Southern California Edison
2025-WMPs – 2025-WMPs

DATA REQUEST SET CalAdvocates - SCE - 2025 WMP - 09

Overhead Detailed Inspection – 2023 Results

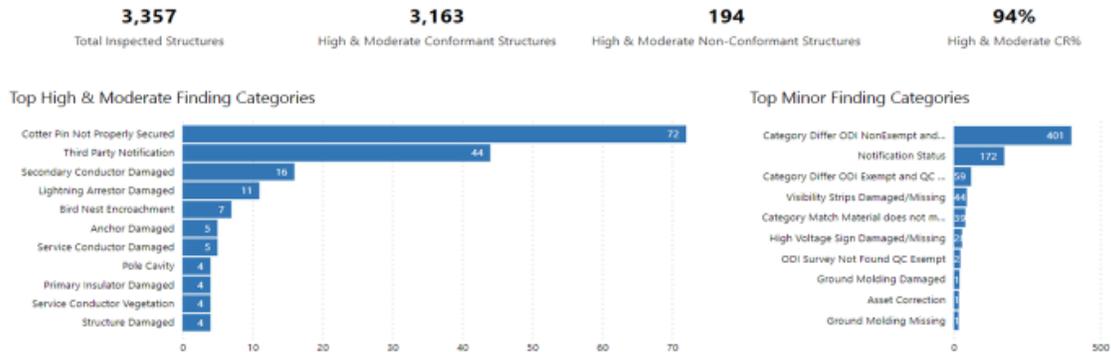
The screenshot contains a graphic that uses the term “high and moderate non-conformant structures.”

Define “high and moderate non-conformant structures” as used here.

The term “high and moderate non-conformant structures” refers to non-conforming structures that contain either a Level 1 (high) or Level 2 (moderate) condition as defined in General Order No. 95 Rule 18.
